## Product Change Notice

Issue Date: 25-September-2023

To introduce new red die source for part number listed below

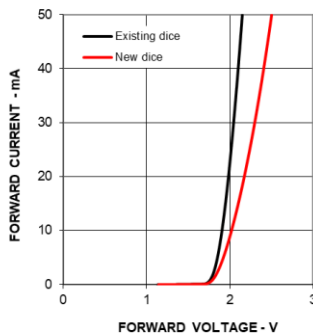
The forward voltage vs forward current is different between the new and current die as illustrated below.

Current	New
Typical Vf @ 20mA	2.1V	2.2V
